THE CITY OF KEY WEST
1300 White Street
Key West, FL 33040

ADDENDUM NO. 2 – RE-BID REST BEACH STABILIZATION
ITB 18-011

RE: **1300 Atlantic Boulevard (C.B. Harvey Rest Beach Park)**
(permit application # T17-8522)

Tree #68: Jamaican Caper (Capparis cynophallophora)

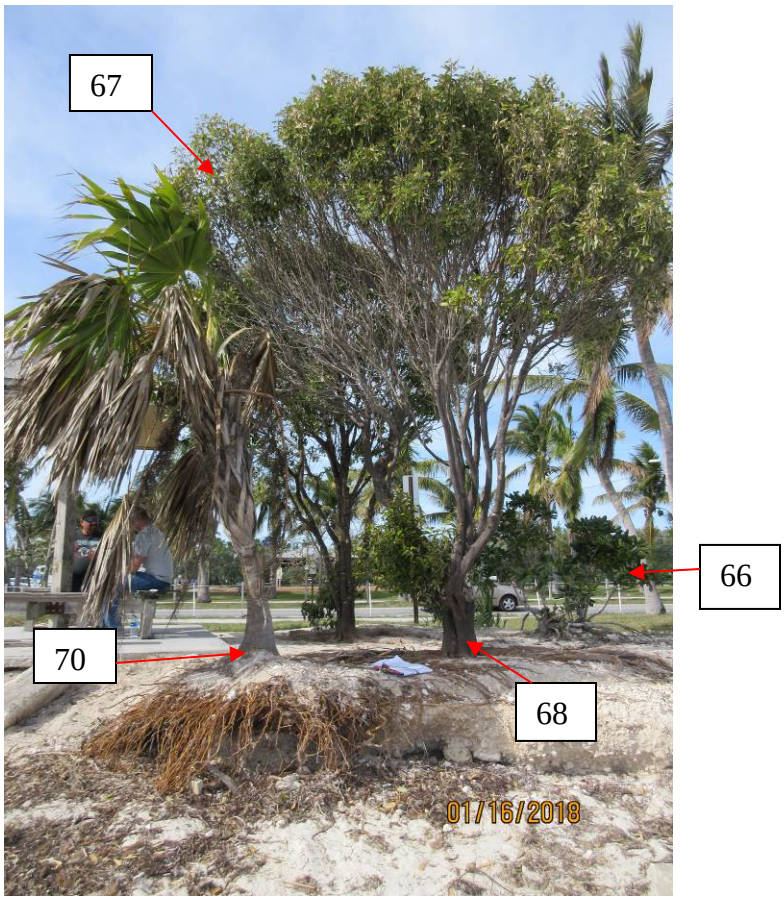
Tree approved for removal. If removed, 13.4 caliper inches of approved replacement trees required.

Sheet Reference:
C-105
Sheet 7 of 23

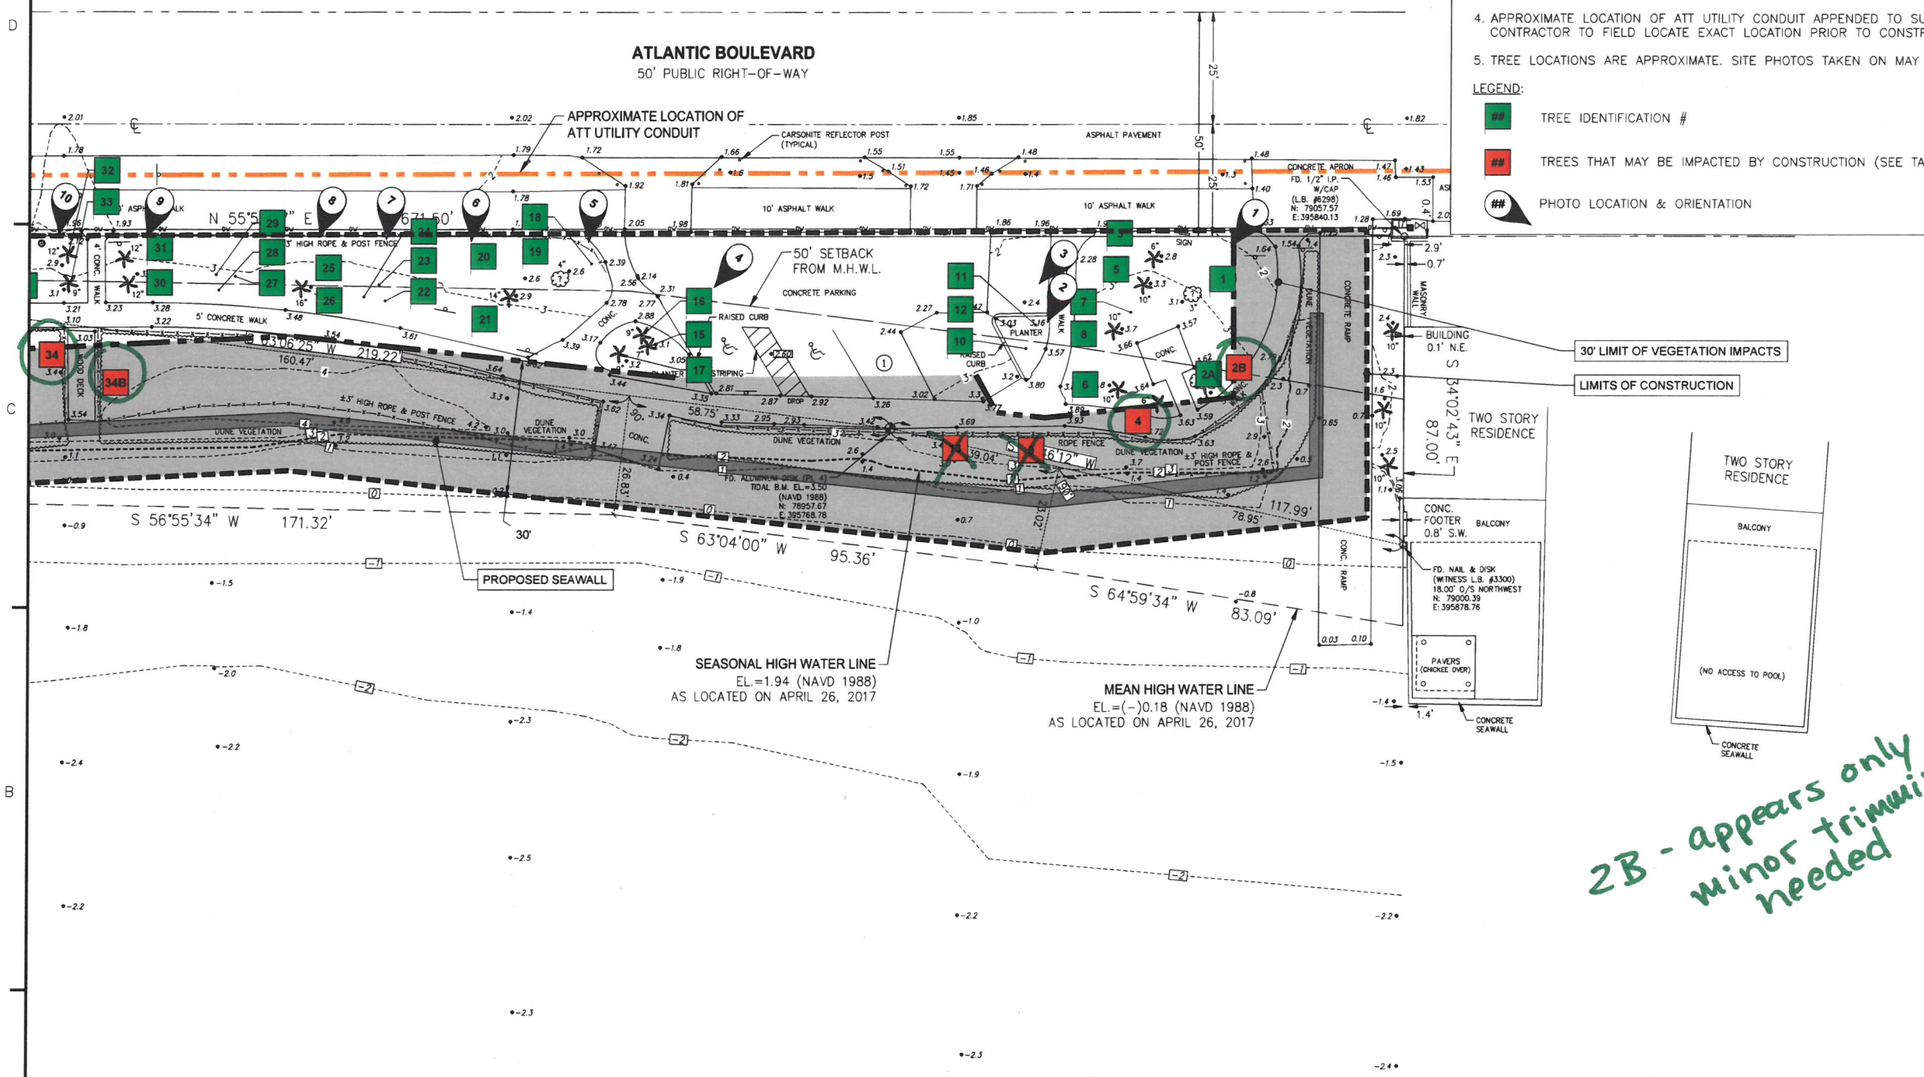
2B - appears only minor trimming needed

Trees already reviewed by Tree Commission circled in green.

Sheet Reference:
C-104
Sheet 6 of 23

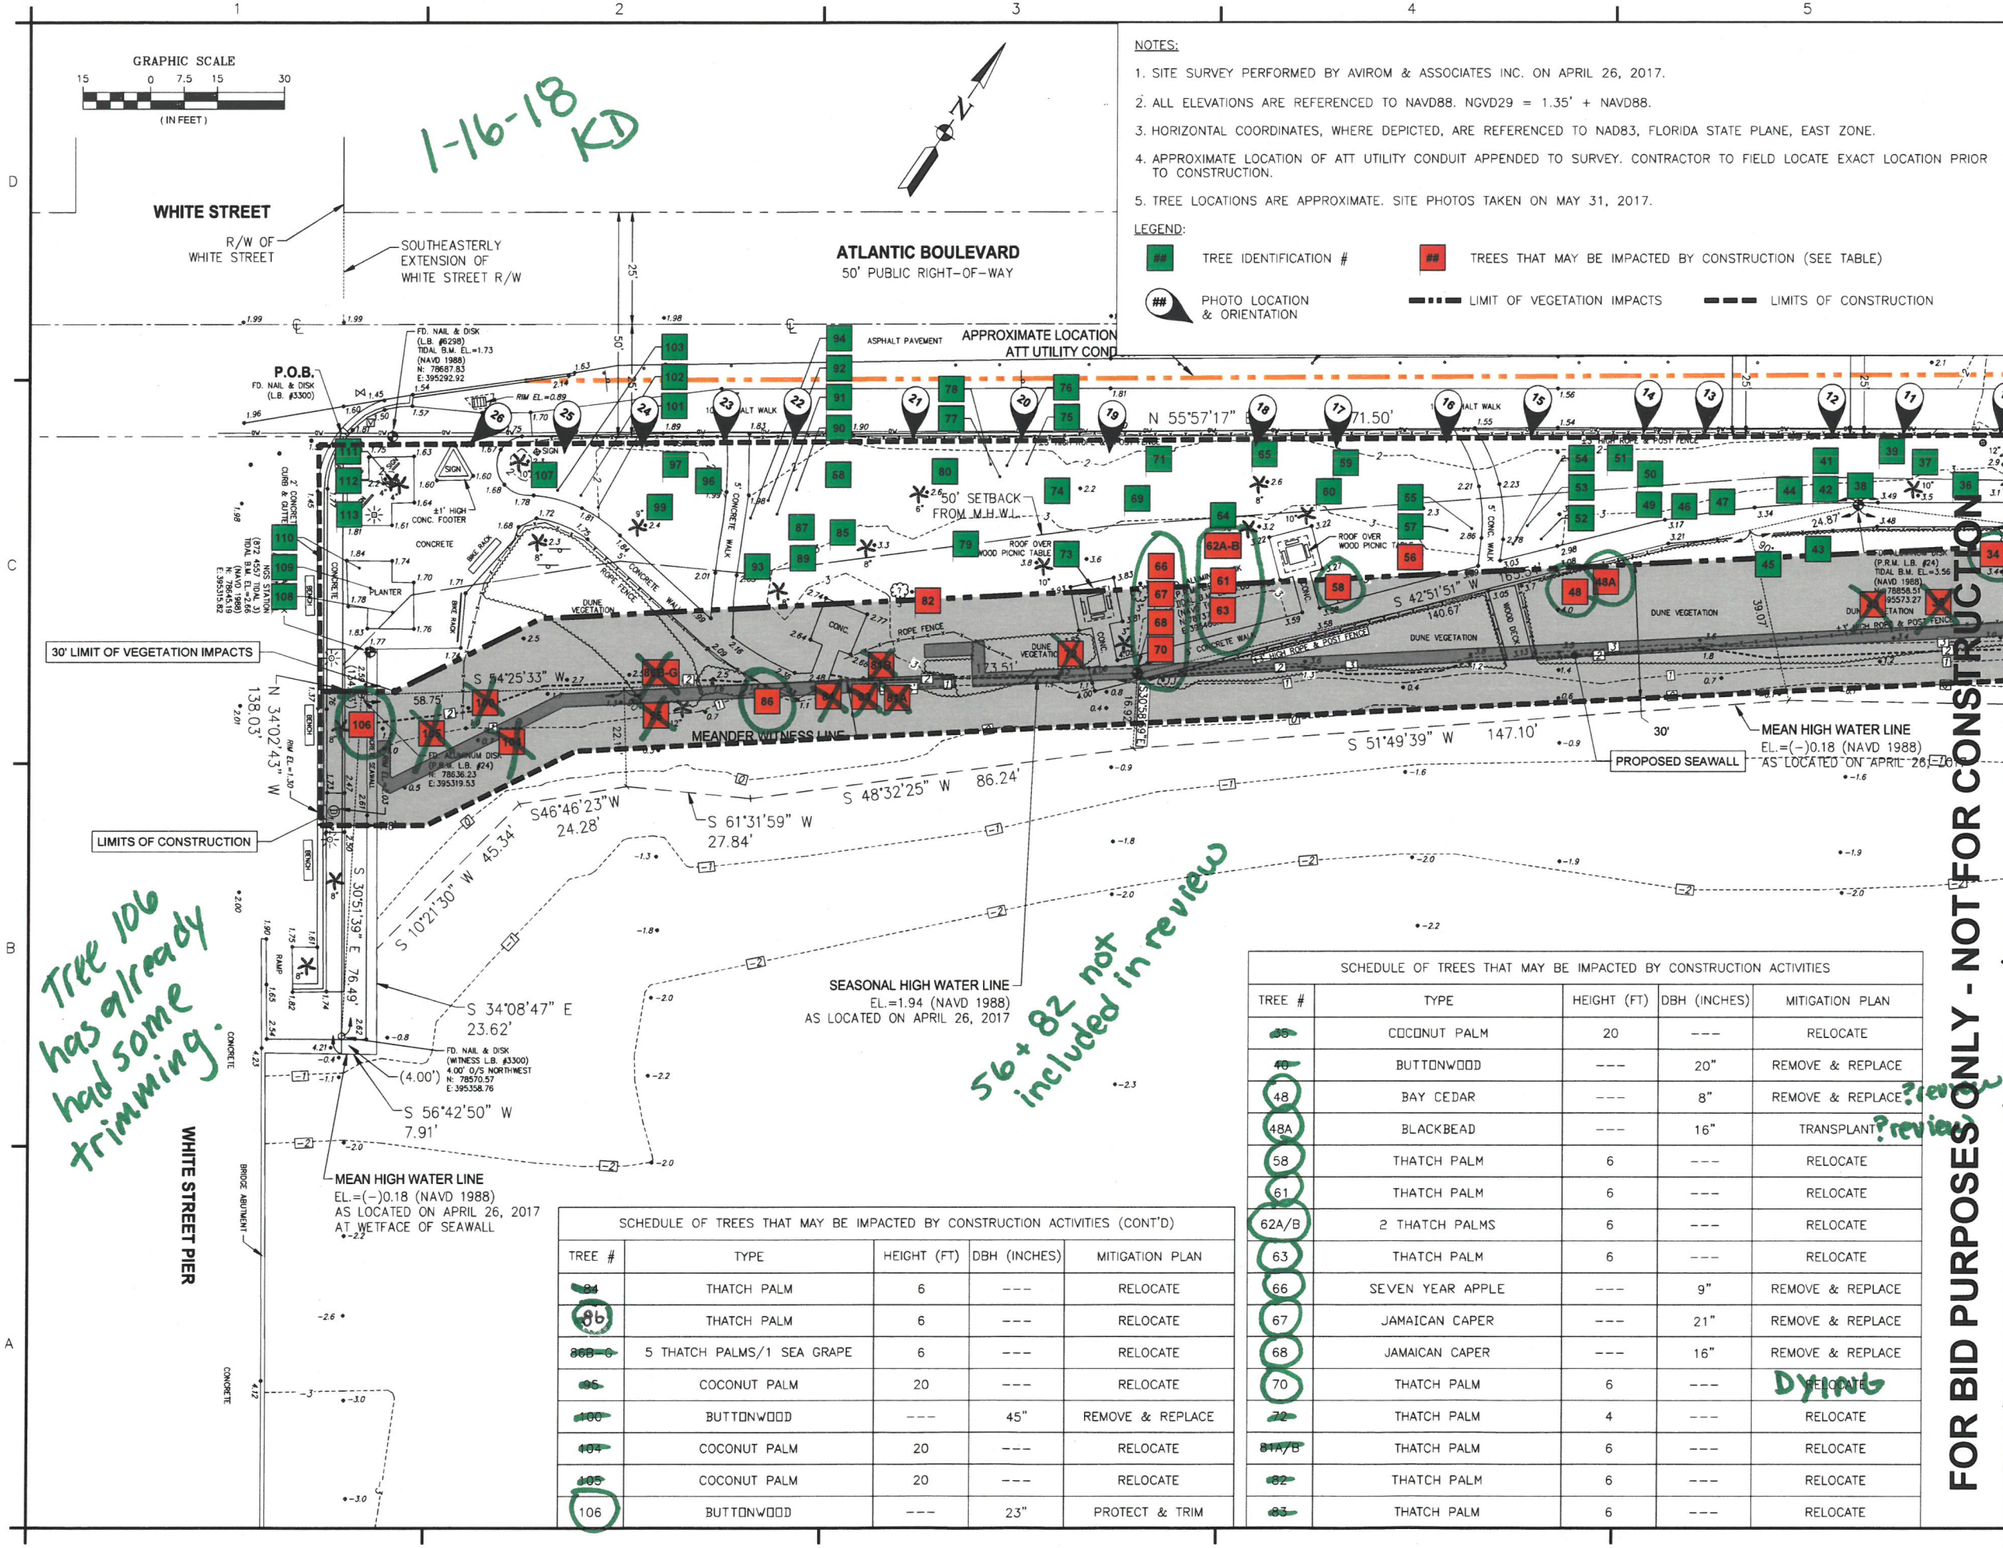
Trees already reviewed by Tree Commission circled in green.
